Cowl Ice Accumulation

Service Category Vehicle Exterior

Section Exterior Panels/Trim

YEAR(S)	MODEL(S)	ADDITIONAL INFORMATION
2016 - 2017	Tacoma

Figure 4.

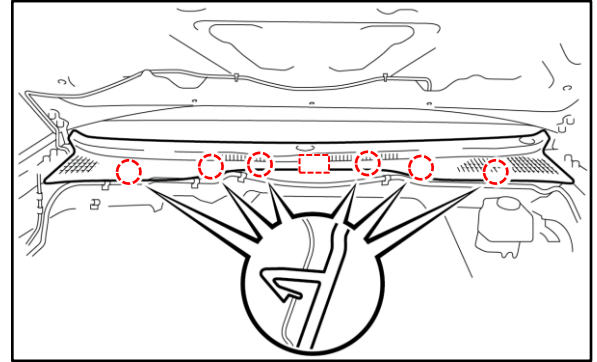
8. Remove the Cowl Top Ventilator Louver Sub-assembly.
 - A. Disengage the six claws and guide.

- B. Disengage the nine guides to remove and discard the OLD Cowl Top Ventilator Louver Sub-assembly.

Figure 6.

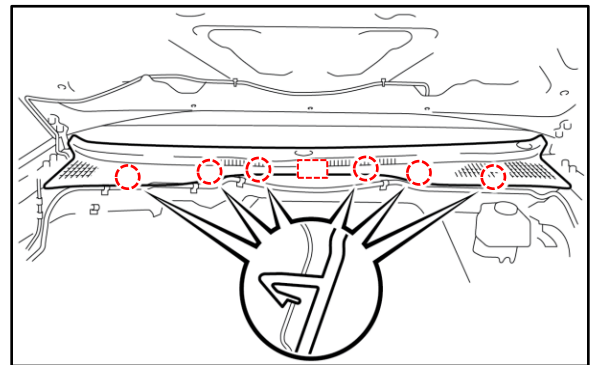
1. Install the NEW Cowl Top Ventilator Louver Sub-assembly.

- A. Engage the nine guides to install the Cowl Top Ventilator Louver Sub-assembly.
